Item ID: D212-664-101

Item Name: Crosstube Fwd High

DART AEROSPACE LTD		Work Order: 93861	
Description: Crosstube High Fwd (205/212/412)		Part Number: D212-664-101	
Inspection Dwg: D212-664-141	Rev: D		Page 1 of 1

DRAWING NO. D212-664-141	TITLE XTUBE ASSY (205/212/412 HI FWD)	REV. D	DART AEROSPACE LTD ENGINEERING ORDER		D.E.O. NO. D212-664-141-D-1	SHEET NO. SHEET 1 OF 2	SCALE NTS
DRAWN	CHECKED	UP	MFG. APPR.	ER	APPROVED	MP	DE APPR.
DATE 11.04.07	DATE 11.04.11		DATE 11.04.12		DATE 11/04/12		DATE 11.04.12

**D212-664-141/-141B
ASSEMBLY DETAIL**

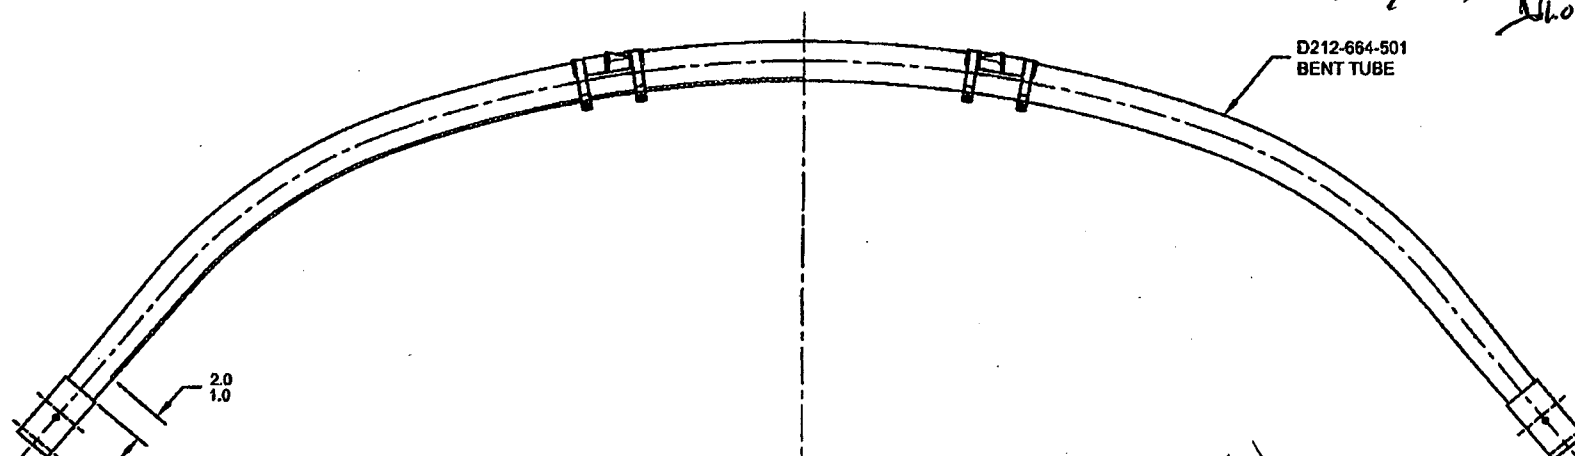
ADD AN INSPECTION WINDOW TO UNDERSIDE OF CROSSTUBE.

- 2) FINISH: CHEMICAL CONVERSION COAT PER DART QSI 005 4.1
PRIME INSIDE AND OUTSIDE PER DART QSI 005 4.2
MASK UNDERSIDE OF CROSSTUBE AS SHOWN (HATCHED AREA) AND
PAINT OUTSIDE PER DART QSI 005 4.2
REMOVE MASKING AND APPLY CLEAR COAT

MASK AREA PRIOR TO PAINTING,
REMOVE MASKING AFTER PAINT
AND APPLY CLEAR COAT
